## Access Compliance Report Public Rights-of-Way (Curb Ramps)

Intersection ID: 11266Main Street:AXAR\_RDCross Street:MULBERRY\_CHURCH\_RDLocation:NEADA ID: D545DE331687Ramp Type:PerpInitial Pass/Fail:FailOverall Compliance:NoSeverity Score:30

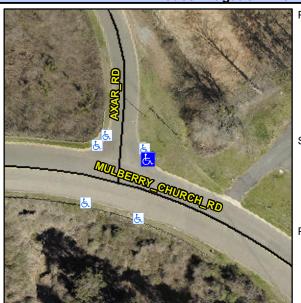
Not Found, R304.5.1, R304.2.2

Compliance Description		Data	Compliance Description		Data
N/A	Ramp Length (in)	67.0	No	Ramp Slope (%)	8.5
No	Ramp Width (in)	35.0	Yes	Ramp XSlope (%)	1.6
N/A	Flare Type LT	N/A	N/A	Flare Type RT	N/A
N/A	Flare Slope LT (%)	N/A	N/A	Flare Slope RT (%)	N/A
N/A	Flare Traversable LT?	N/A	N/A	Flare Traversable RT?	N/A
N/A	Landing Length (in)	N/A	N/A	DWS Provided?	N/A
N/A	Landing Width (in)	N/A	N/A	DWS Contrast?	N/A
N/A	Landing Slope (%)	N/A	N/A	DWS Length (in)	N/A
N/A	Landing X Slope (%)	N/A	N/A	DWS Full Width?	N/A
N/A	Landing Curb? (Y/N)	N/A	N/A	DWS Offset (in)	N/A
N/A	Shared Landing?	N/A			
N/A	Gutter Ponding?	N/A	N/A	Gutter Slope (%)	N/A
N/A	Gutter Lip Ht (in)	N/A	N/A	Gutter X Slope (%)	N/A
N/A	Painted X Walk1?	No	N/A	Painted X Walk2?	N/A
	X Walk 1 Direction	To S		X Walk 2 Direction	N/A
N/A	X Walk 1 Width (in)	N/A	N/A	X Walk 2 Width (in)	N/A
	X Walk 1 Slope (%)	1.7		X Walk 2 Slope (%)	N/A
	X Walk 1 X Slope (%)	0.7		X Walk 2 X Slope (%)	N/A

Remove & Replace Entire Ramp.
